MATERIALS LICENSE

3. License number 42-02964-01 is amended in its entirety to read as follows:

SUBJECT: LICENSE AMENDMENT

SUBJECT: TECHNICAL ASSISTANCE REQUEST; WESTERN ATLAS
INTERNATIONAL, INC.; LICENSE NUMBER 42-02964-01

BRITISH-BORNEO EXPLORATION, INC
EAST CAMERON BLOCK 2
OCS-G 10605 #A-1 (fka #2)

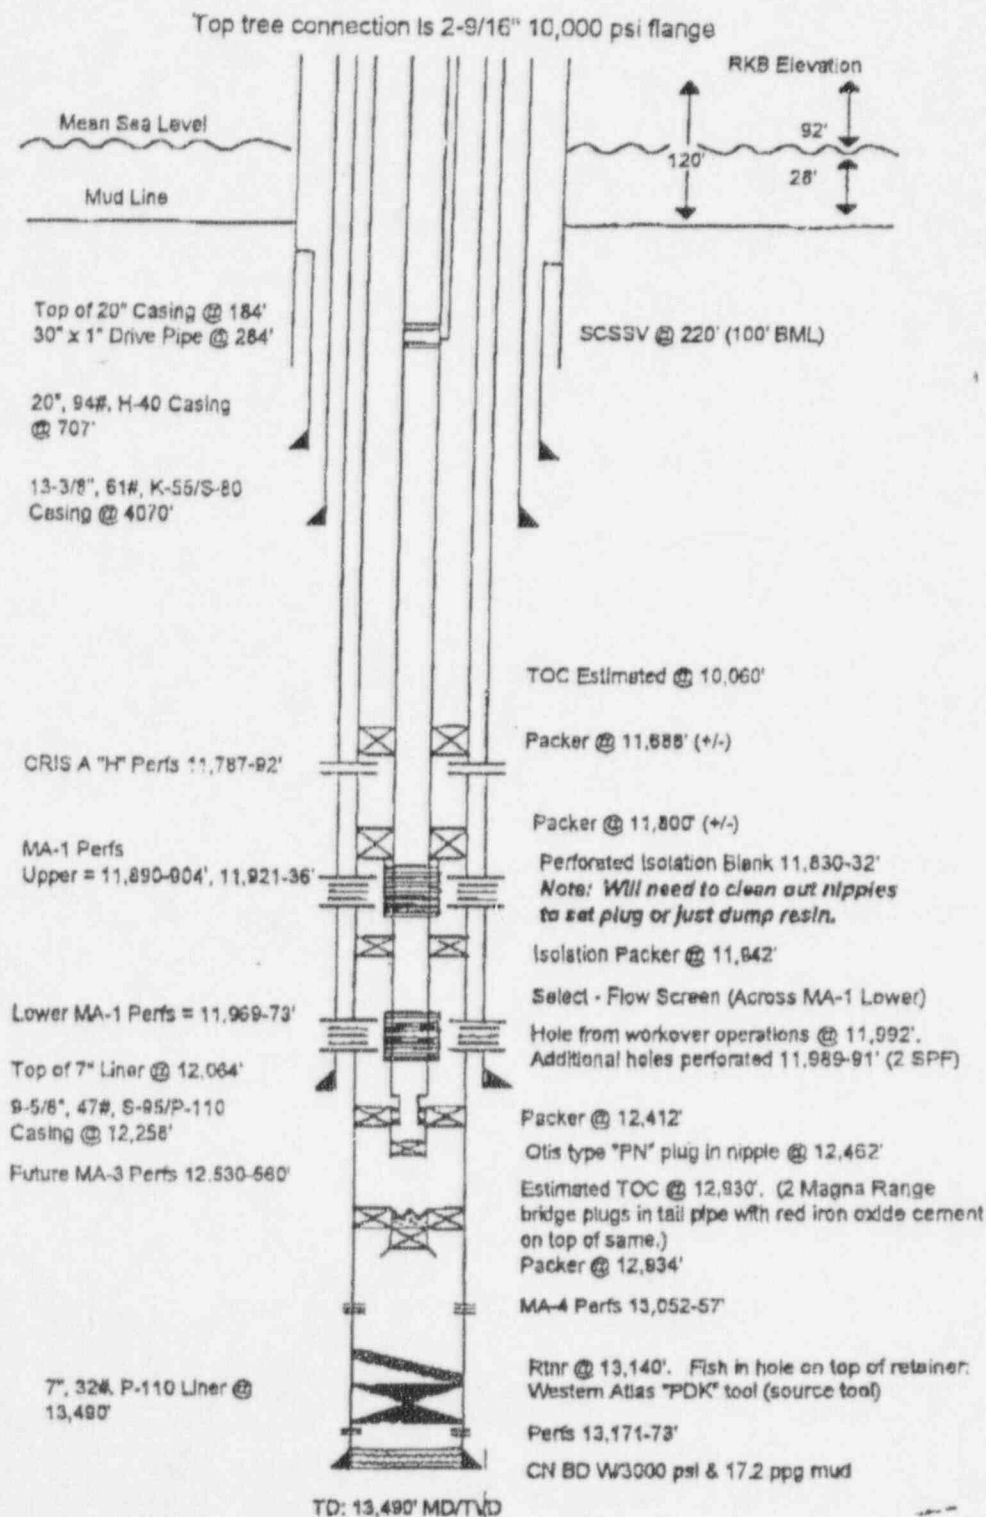
Please find enclosed an updated well schematic that shows the
location and depth of the plugs that isolate the production from
the PDK logging tool and radioactive source.

BRITISH-BORNEO
EAST CAMERON BLOCK 2
OCS-G-10605 #2

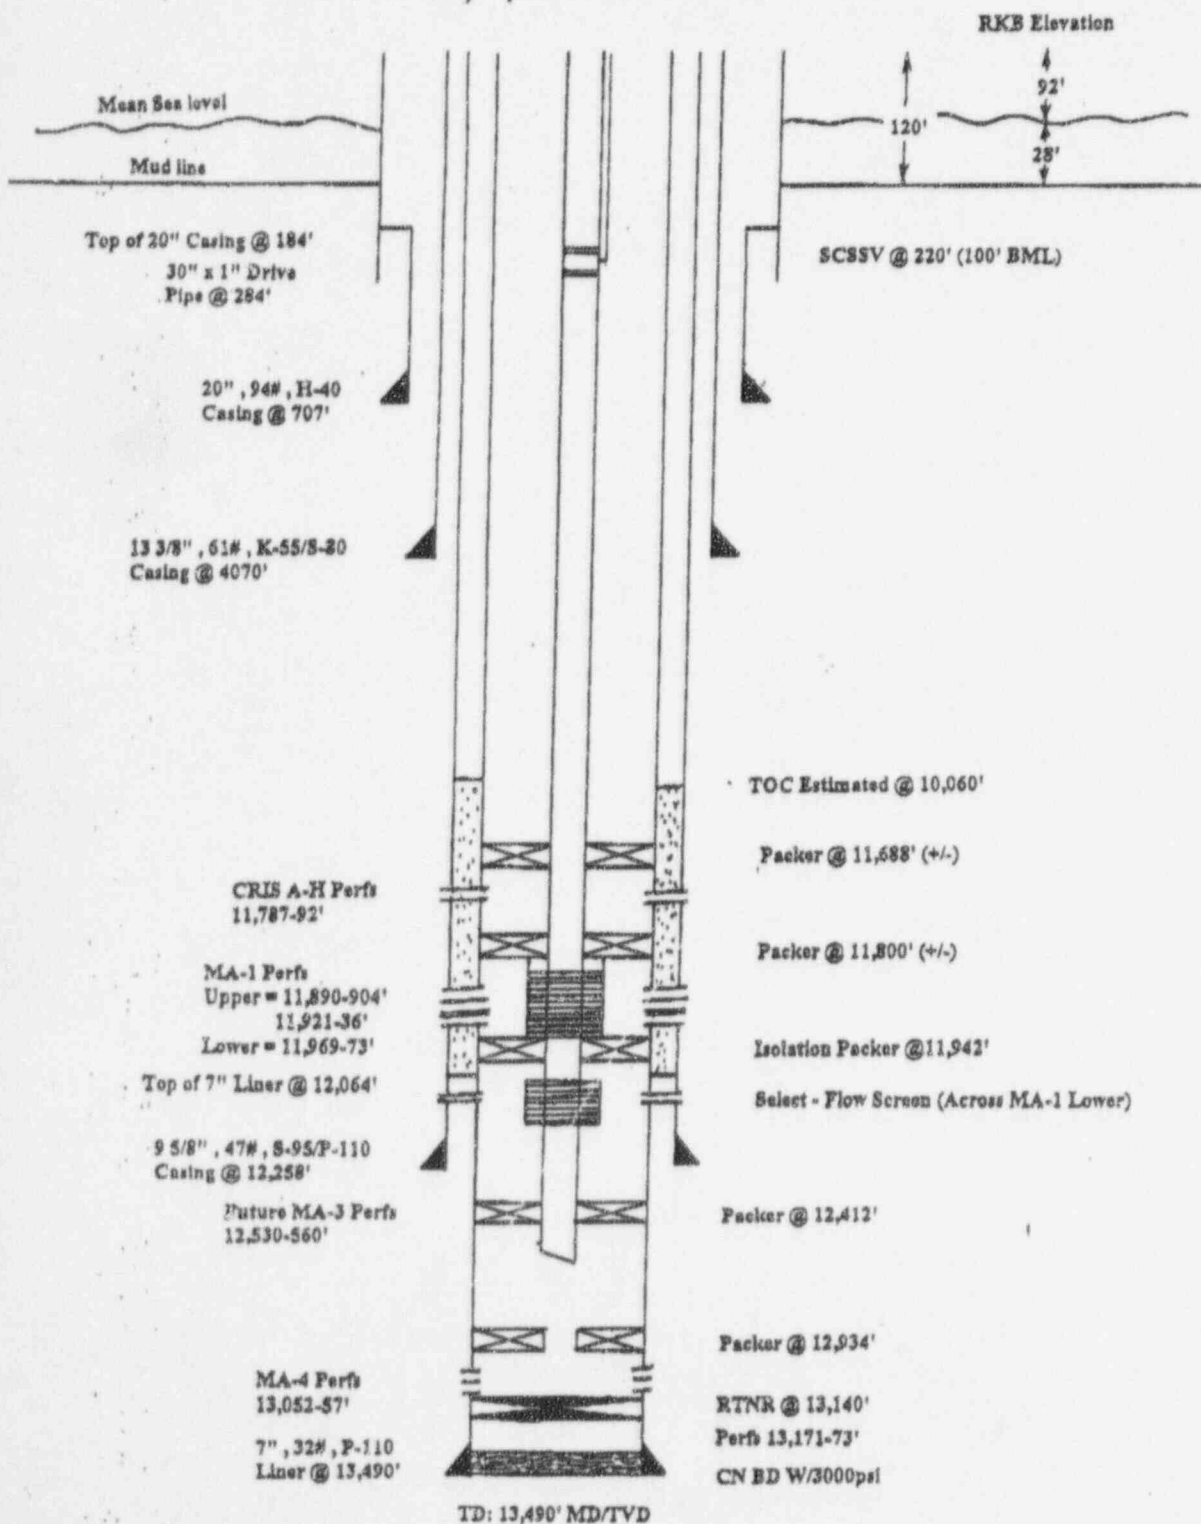
As shown in the enclosed schematic, the top and bottom of the tools are as follows.

Description	Top Depth	Bottom Depth
Sinker Bars	13,082'	13,107'
PDK (logging tool)	13,107'	13,140'
Neutron Generator	13,136'	
(located inside logging tool)

BRITISH TORNEO
EAST CAMERON BLOCK 2
OSC-G-10605#2

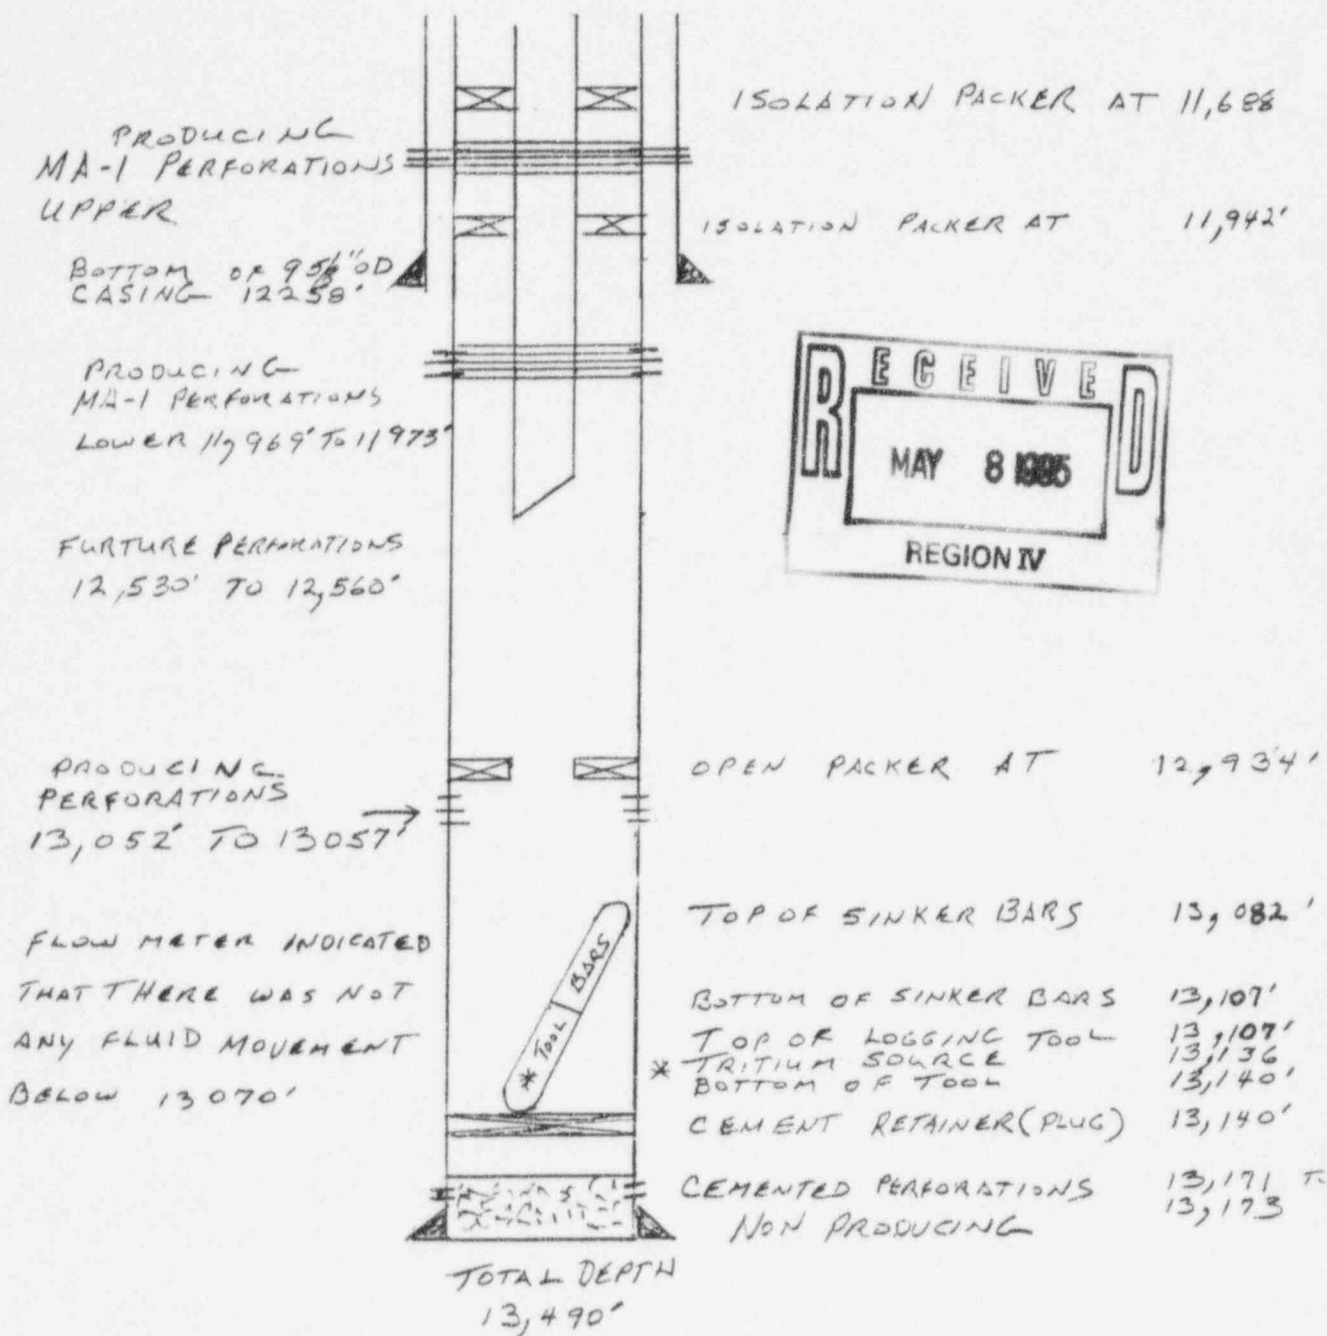
EXPANDED VERSION OF WELL SCHEMATIC!
